Technical Service Bulletin

GROUP BODY ELECTRICAL	NUMBER 25-BE-005H-2
DATE MAY 2025	MODEL(S) SEE BELOW

SUBJECT: HORN ASSEMBLY REPLACEMENT
(WARRANTY EXTENSION Z03)

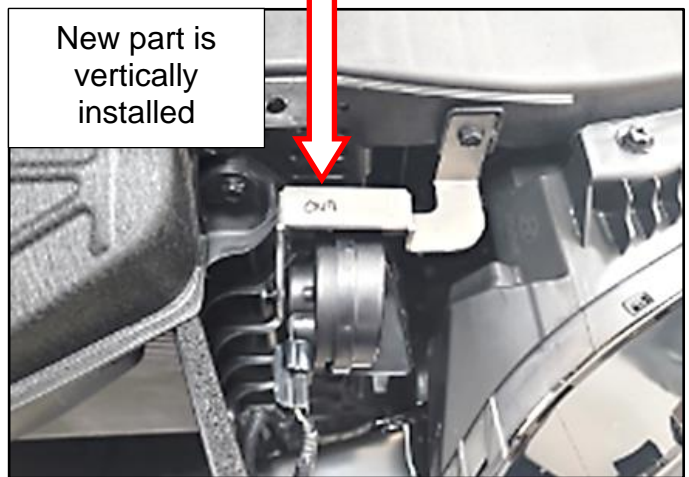
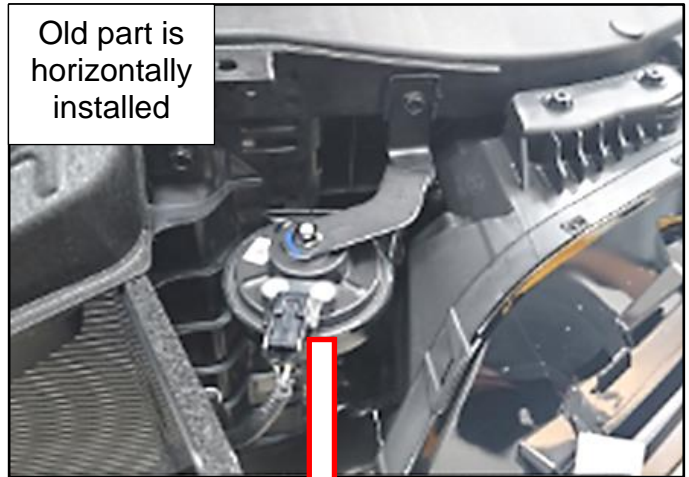
3. Replace both horns (high and low) in a vertical orientation by connecting the horn connectors to the external wirings.

Ensure the horns (high and low) are installed vertically with the bell holes facing downward to prevent water intrusion.

Part Number	Remarks
96611-AA900QQH 96621-AA900QQH	Extension wiring included
96611-AA700QQH 96621-AA700QQH	NO extension wiring
96611-AA800QQH 96621-AA800QQH	NO extension wiring
